## SECTION 009113 – ADDENDUM ONE

- A. Project Name: 23041 – Scott County Schools Reroofing.
- B. Owner: Scott County School District, 110 Commerce Loop, Forest, Mississippi, 39074.
- C. Architect: Dale | Bailey, an Association, 188 East Capitol Street, Suite 250, Jackson, MS 39201.
- D. Architect Project Number: 23041
- E. Date of Addendum One: 7 November 2023

## New Roof Drain Detail

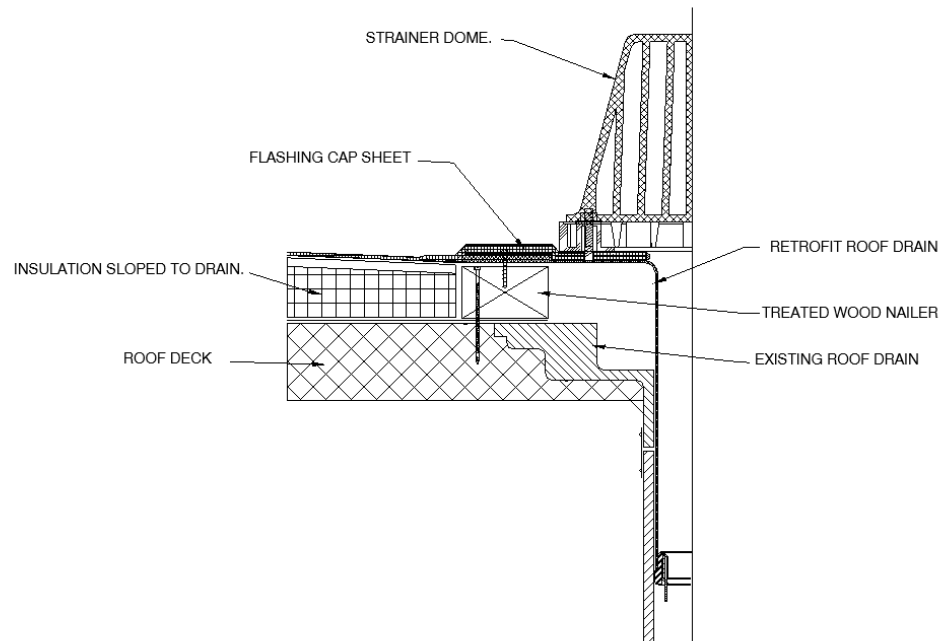
- B. SHEET A-003 – MORTON ELEMENTARY ROOF PLAN (ALT #2) (Reissued). Delete this sheet in its entirety and replace it with the attached. Indicated high-low roofs on drawings; indicated canopy to be reroofed on the building near the newly renovated cafeteria.
- C. SHEET A-511 – MOD-BIT ROOF DETAILS (Not Reissued). Add the following New Roof Drain Detail. See below. The Contractor shall clear out all roof drains prior to installing new domes and drains.

**1 Scott Central Attendance Center Roof Plan (Alt #1)**  
1" = 30'-0"

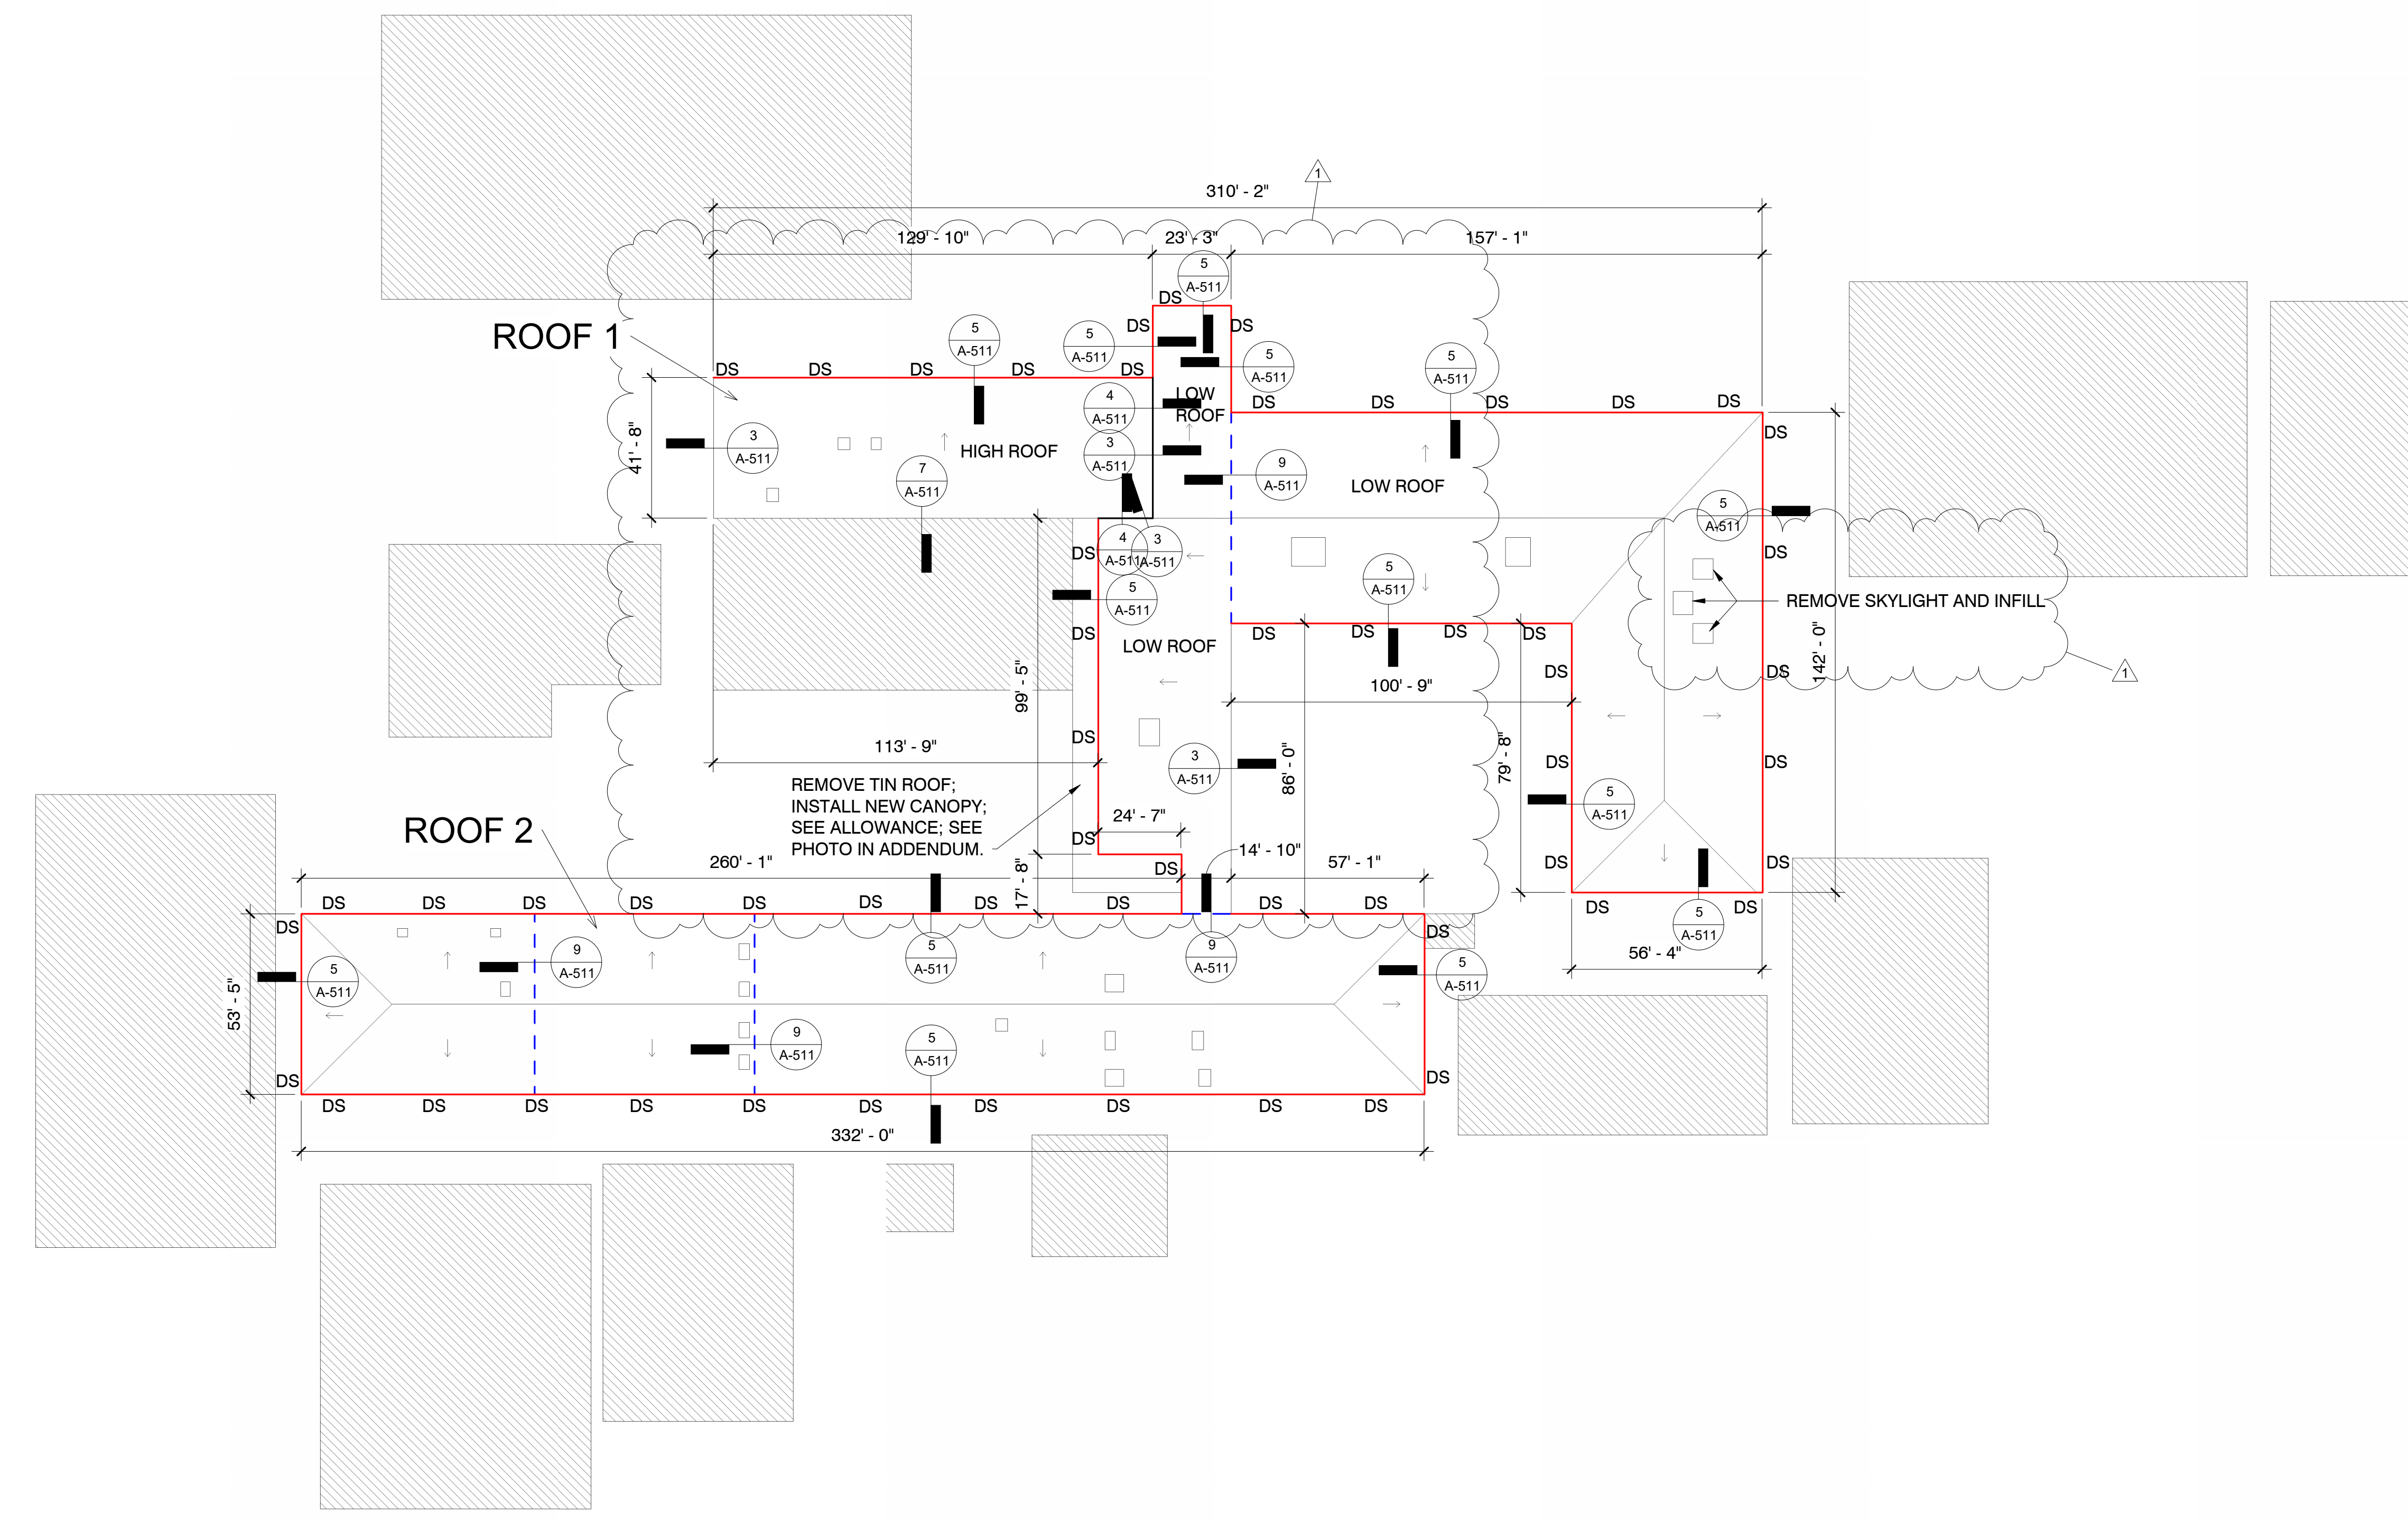
- A. SHEET A-002 – SCOTT CENTRAL ATTENDANCE CENTER ROOF PLAN (ALT #1) (Reissued). Delete this sheet in its entirety and replace it with the attached. Added notes to remove skylights; indicated high-low roofs on drawings; added notes to remove sheet metal on roof near the cafeteria and install new canopy. See allowance. See photo for sheet metal to be removed.
